Building and Development Dispute Resolution Committees—Decision

Appeal Number:	72-10
Appellant:	Lyn Smith
Assessment Manager:	Burnett Country Certifiers
Concurrence Agency: (if applicable)	Bundaberg Regional Council (Council)
Site Address:	390 Bourbong Street, Bundaberg and described as Lot 277 on RP 881865 - the subject site.

Appeal

DWG TITLE - SITE PLAN
 DWG No. - SP-838-10
 OWNER - Lyn Smith
 ADDRESS - 390 Bourbong St
 DATE - 27/08/10
 AUTHOR - Bruce Lane

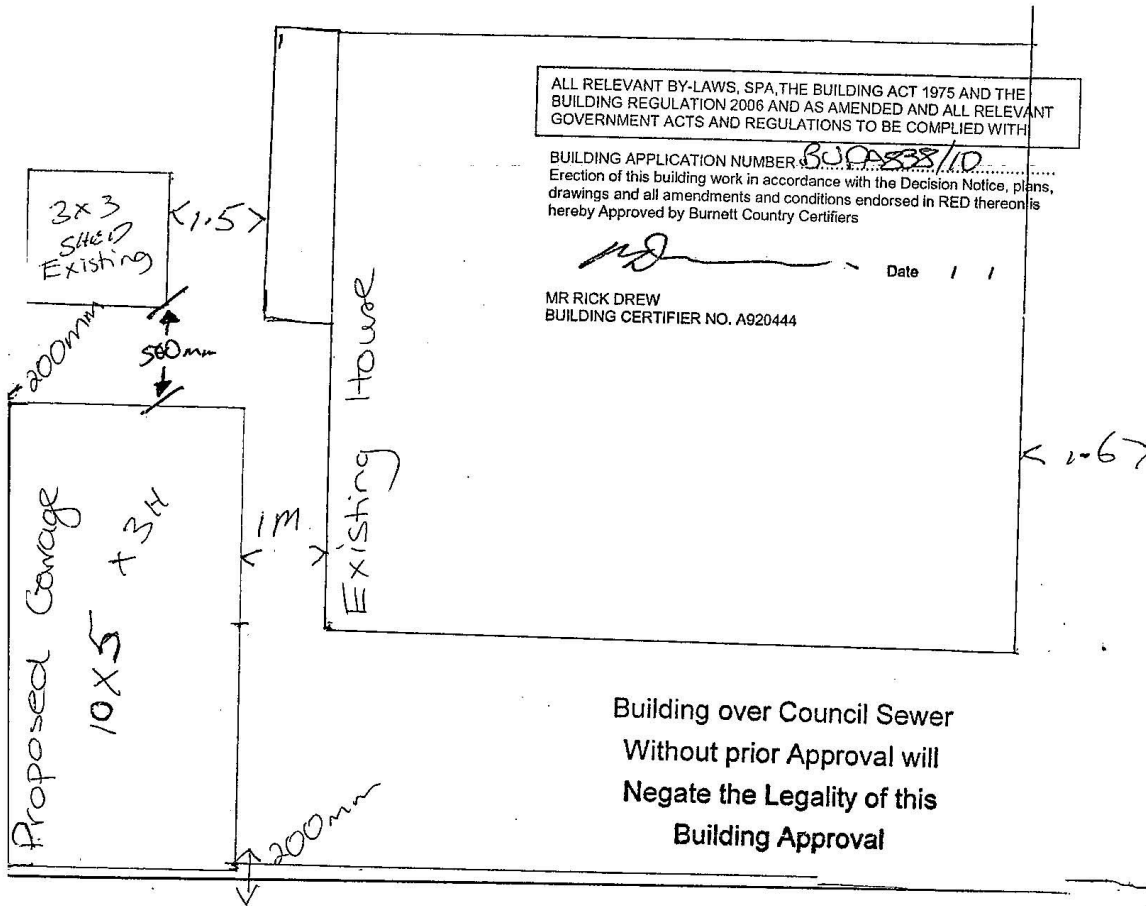
- The assessment manager is directed to re-assess the development application for building works in relation to the garage and carport.
- The re-assessment shall be on the basis that the concurrence agency has no objections to the siting of the carport part with a road setback of 200mm to its outer most projection from the

existing garden shed of 13.0m (10m combined carport and garage, 3m existing garden shed) 200mm from the northern property boundary as defined on the Site Plan DWG001 as annotated by the Committee and contained within Appendix A.

- The proposed siting of the combined garage and carport on the subject site would result in a road setback of 200mm to the carport and result in an overall length of structures within 1.5 m of the northern side boundary of 13m (combined garage and carport 10m and existing garden shed 3m) which is contrary to Acceptable Solution A1(a)(i) and A2(d)(ii) of QDC MP1.2.
